# ES\_LPC435x/3x/2x/1x Flash

## Errata sheet LPC435x/3x/2x/1x flash-based devices

Rev. 4 — 22 July 2013

Errata sheet

### 3.5 ISP.1: 'J' command in ISP mode swaps last two items

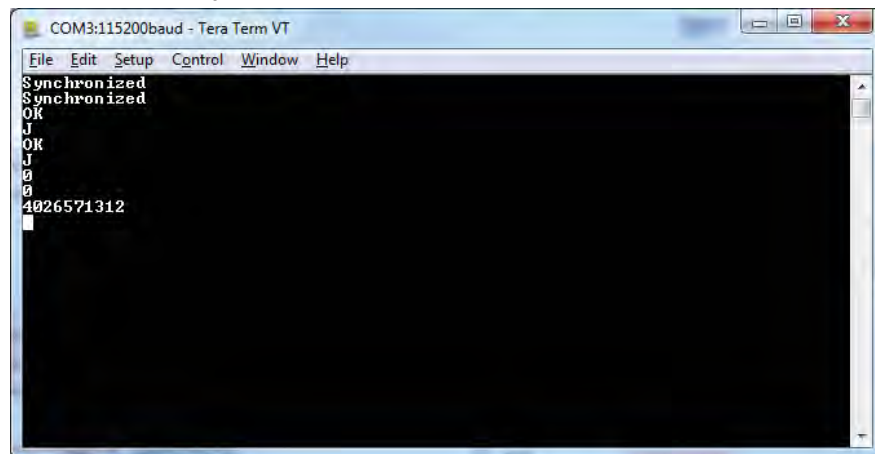
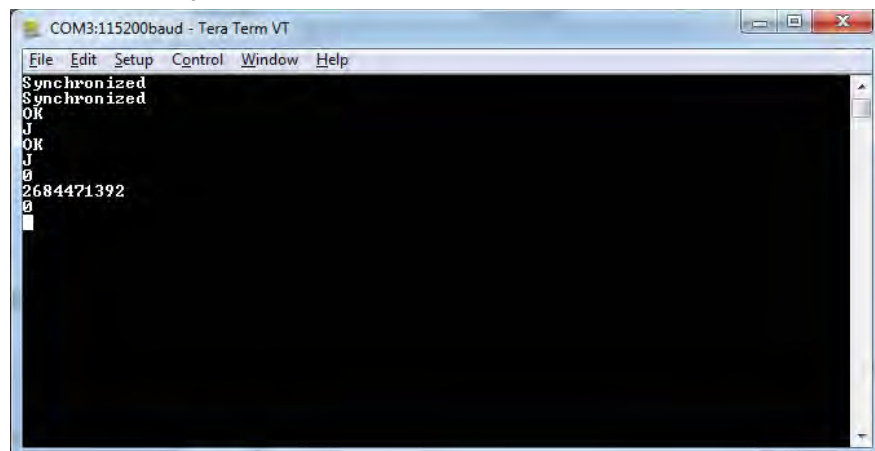
The 'J' command in ISP mode should return an error code, followed by an ASCII string representation of the part ID, followed by a 0. However what is actually returned is the error code, followed by a 0, followed by an ASCII string representation of the part ID. The problem is the last two items returned are swapped.

Incorrect example:

Correct example:

There is no work-around for this problem.

## 3.7 PMC.1: PMC.x power management controller fails to wake up from Deep Sleep, Power Down, or Deep Power Down

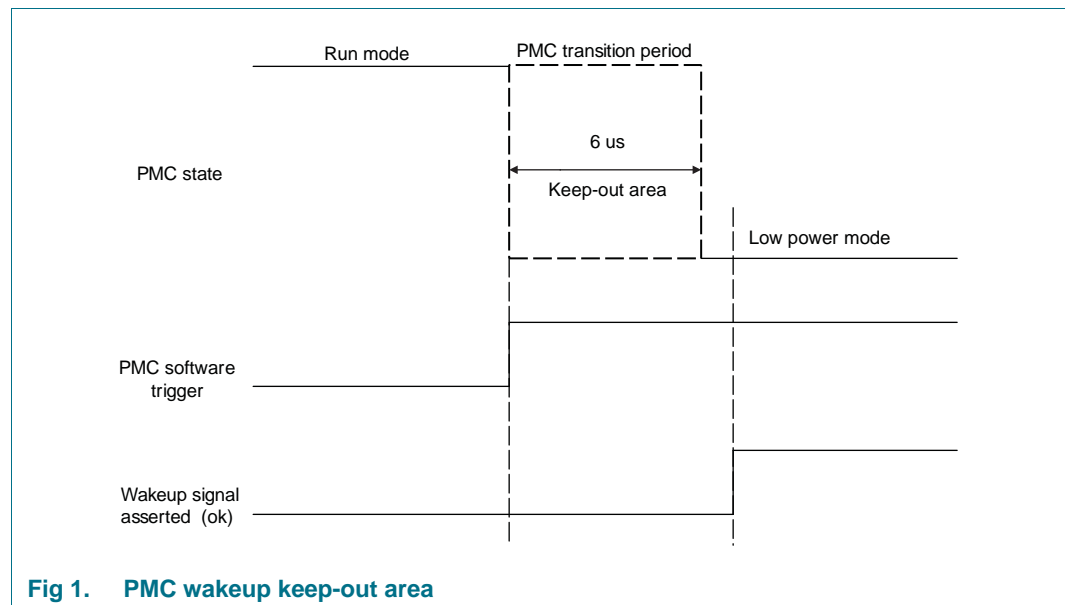
When the chip is in a transition from active to Deep Sleep, Power Down, or Deep Power Down, wakeup events are not captured and they will block further wakeup events from propagating. The time window for this transition is 6  $\mu$ s and is not affected by the chip clock speed. After a wakeup event is received during the PMC transition, the chip can only recover by using an external hardware reset or by cycling power.

Make sure that a wakeup signal is not received during the Deep Sleep, Power Down, or Deep Power Down transition period. An example circuit to work around this could include an external 6  $\mu$ s one shot which could be triggered via software using a GPIO line when entering Deep Sleep, Power Down, or Deep Power Down mode. The one-shot's output could be used to gate the wakeup signal(s) to prevent receiving a wakeup signal during the PMC transition period. Depending on the system design, it may also be needed to latch the wakeup signal(s) so that they will still be present after the one-shot's 6  $\mu$ s timeout.

## 3.9 USB.1: The USB controller USB0 is unable to communicate with a low-speed USB peripheral in host mode when using full-speed hub

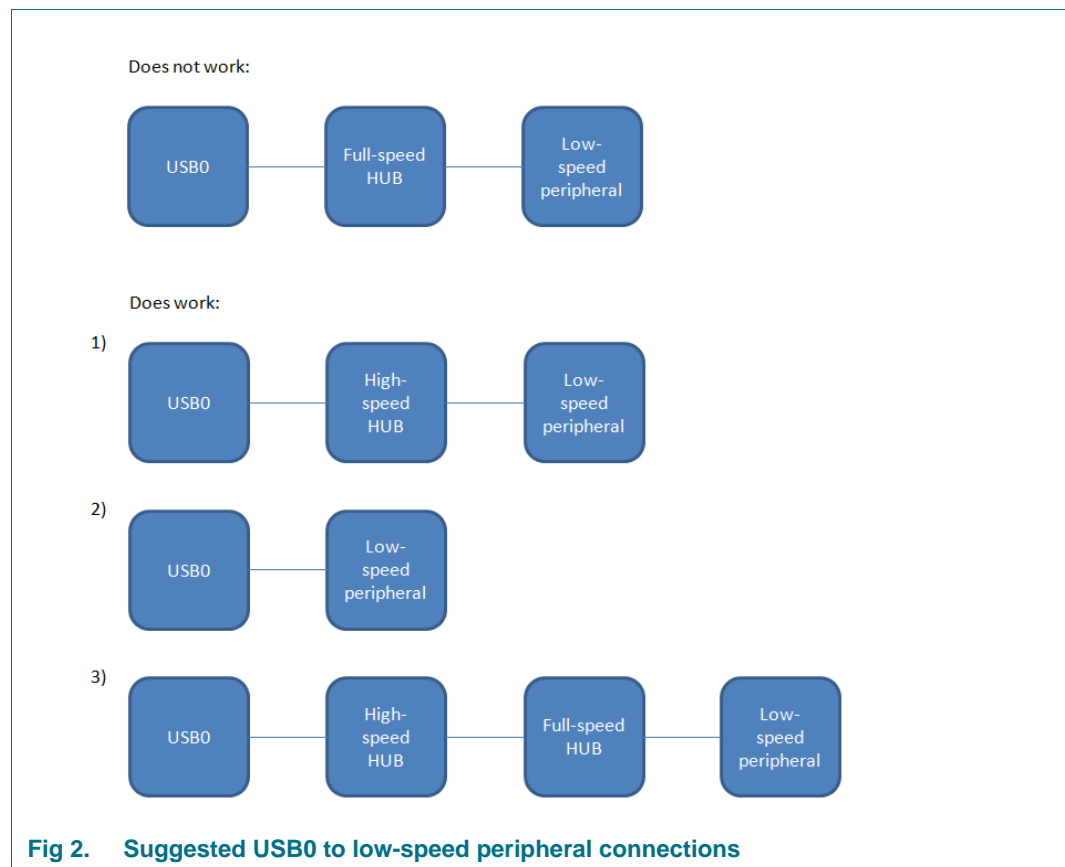
The USB controller called USB0 is unable to communicate with a low-speed USB peripheral in host mode when there is a full-speed hub directly connected to the USB0 port and a low-speed peripheral is connected in the tree somewhere below this full-speed hub. Only USB0 has this problem; the other USB controller, USB1 does not.

There is no work-around for this problem. It is suggested that the low-speed USB peripheral is either connected directly to USB0 or a high-speed hub is placed between that peripheral and USB0.
